CCK-2564.0-18-26 HEB BP-07

ADDENDUM #4

CCK-2564.0-18-25
Question and Response Log

SK-003.2 (ADD #4)

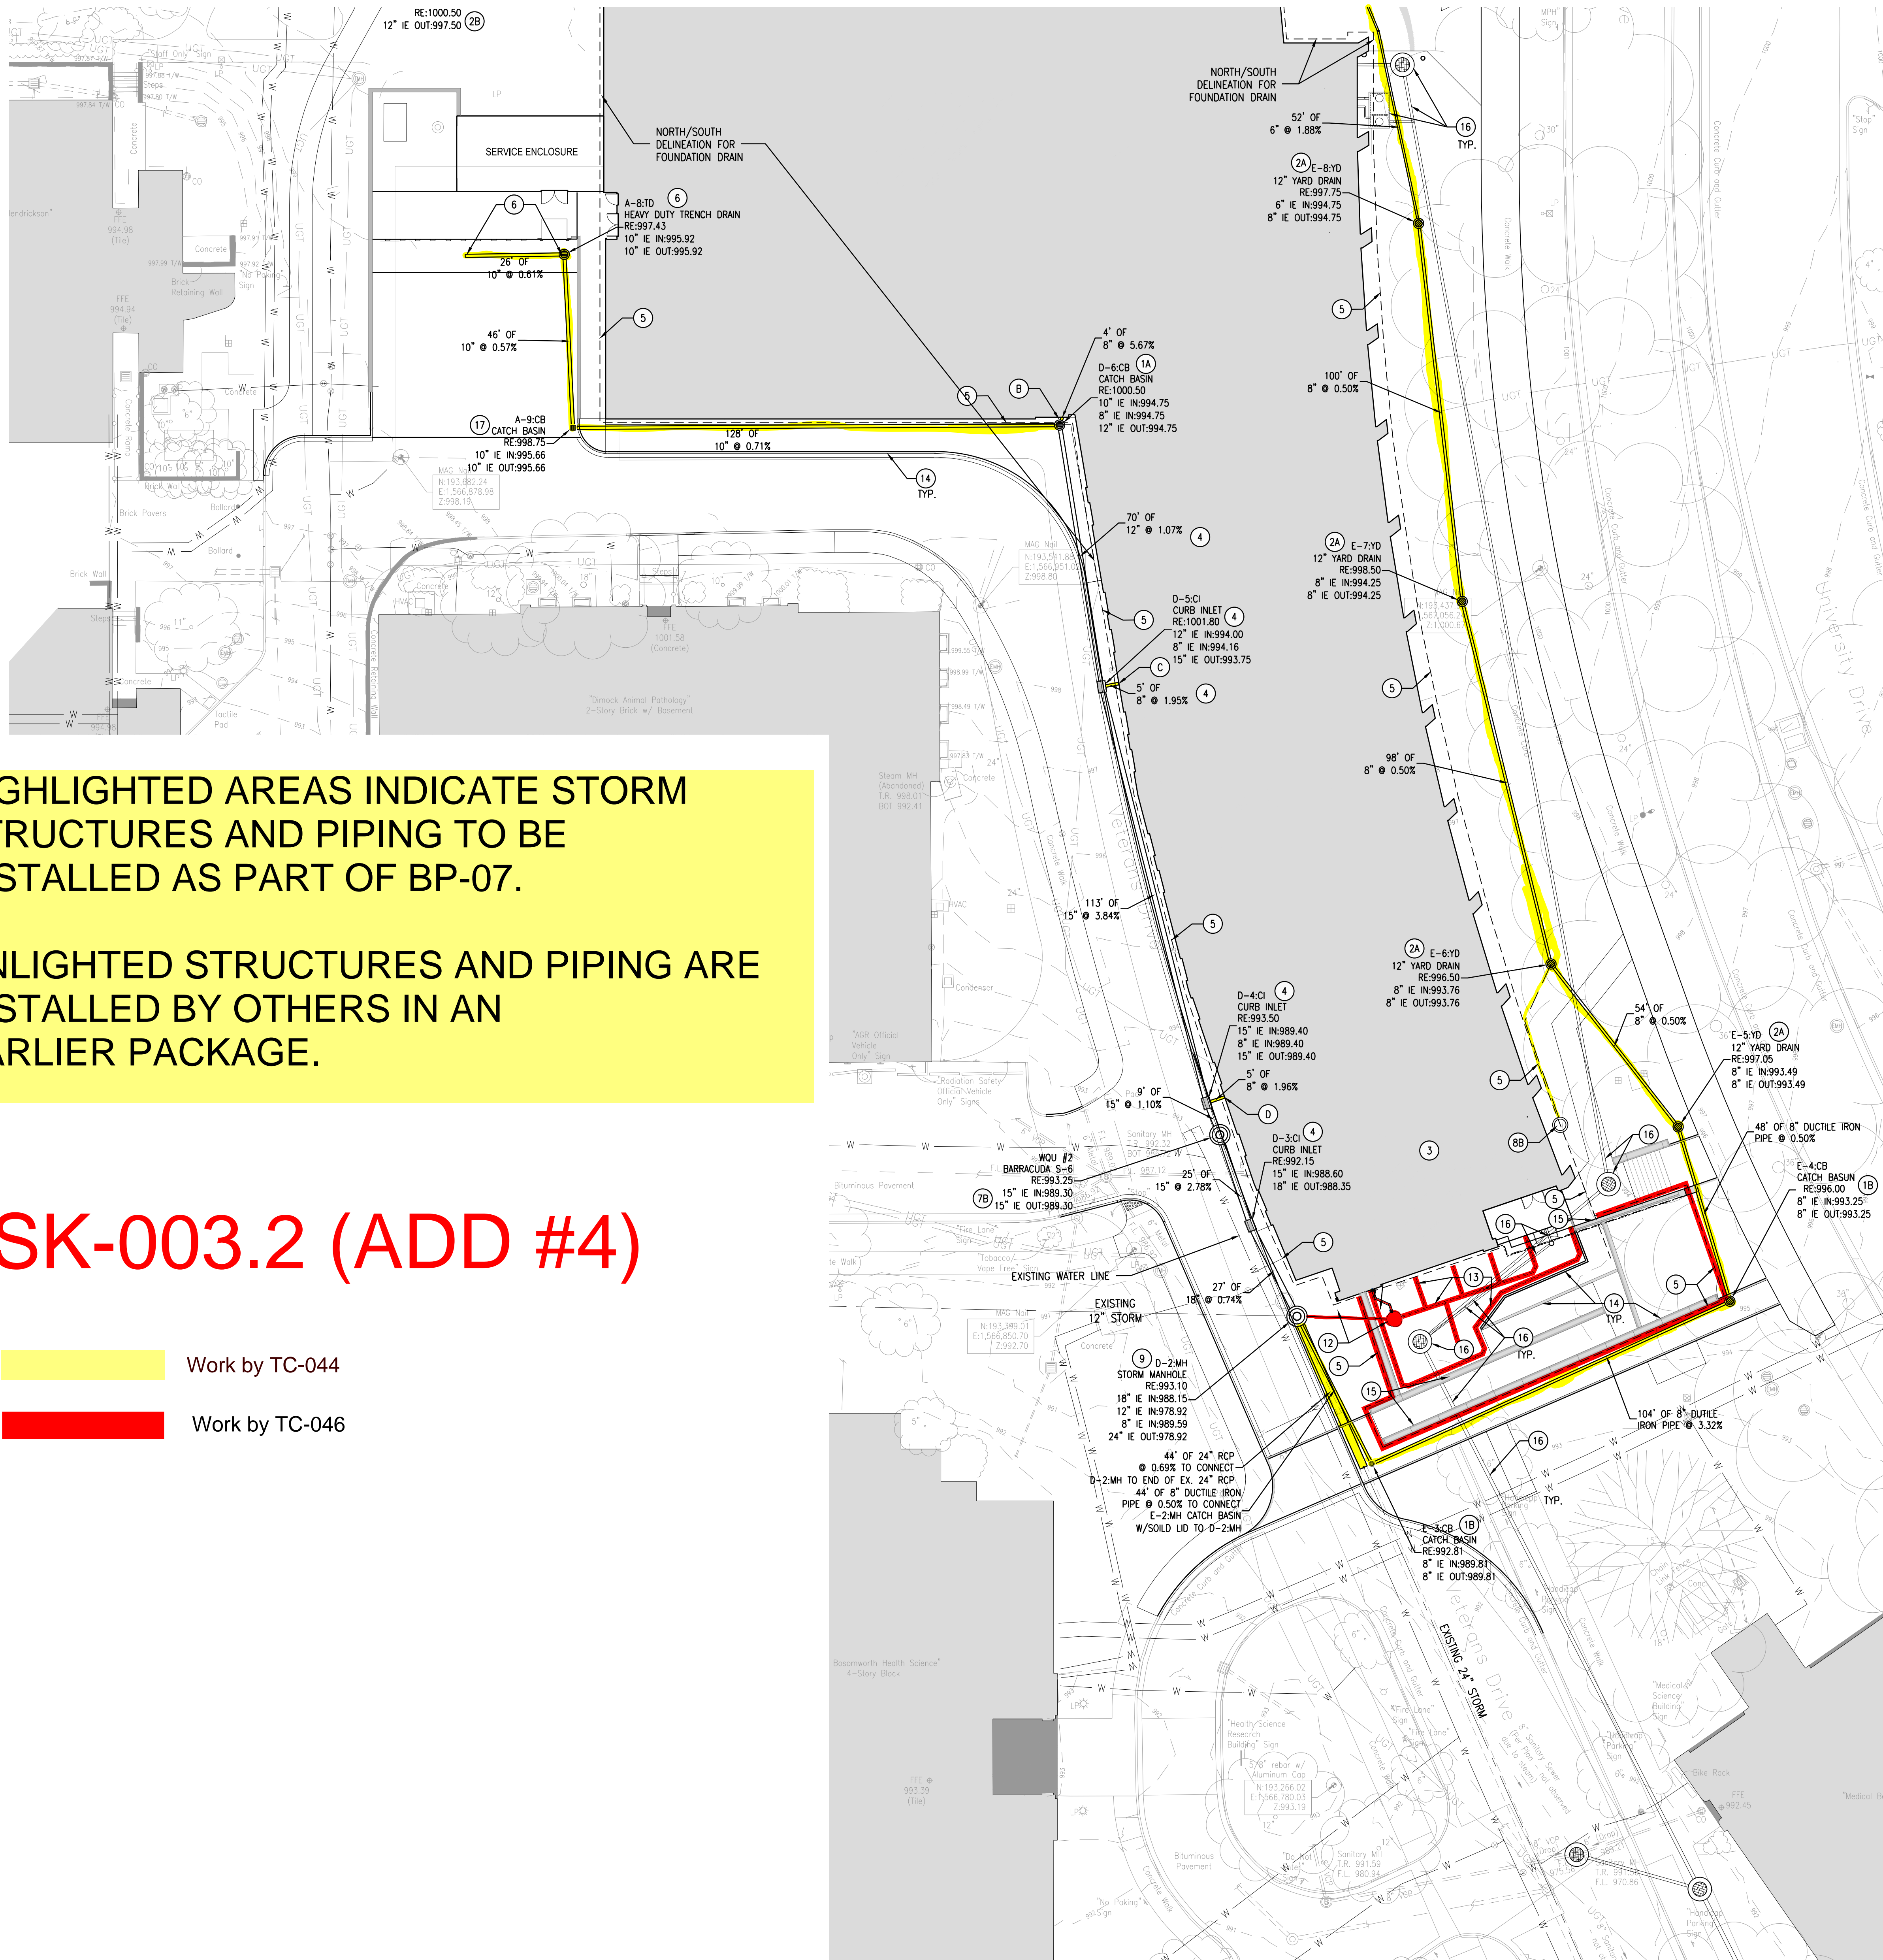
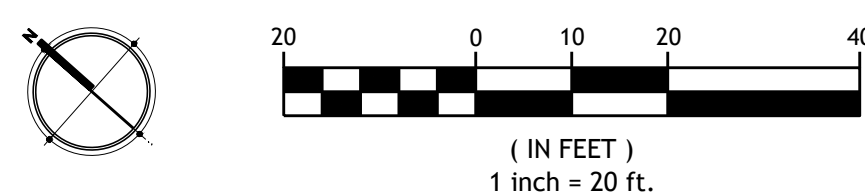
HIGHLIGHTED AREAS INDICATE STORM STRUCTURES AND PIPING TO BE INSTALLED AS PART OF BP-07.
